Product Change Notification: BLAS-16DMDR130

CCB 7483 Final Notice: Implement packing material changes for selected PSDS and SIC products available in SOT-227, TO-220, TO-247, TO-263 and TO-268 packages at FSTS and TEAM final test sites.

CCB 7483
Pre and Post Change Summary
PCN# BLAS-16DMDR130

ESD Label

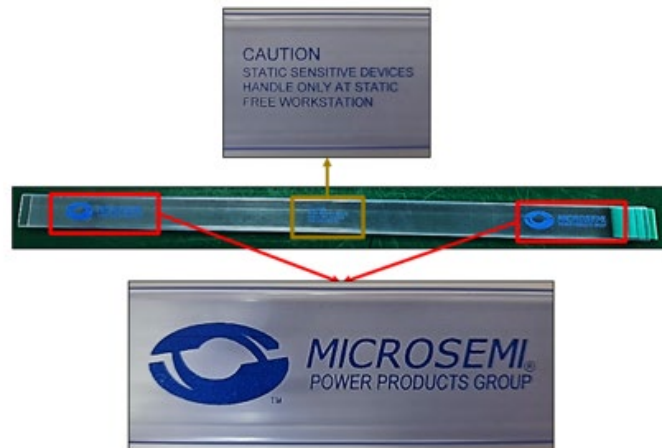
Pre Change	Post Change
<p>For FSTS and Team Pacific : Not comply at FSTS/Team Pacific</p> 	<p>To change the new inner box with ESD symbol</p>
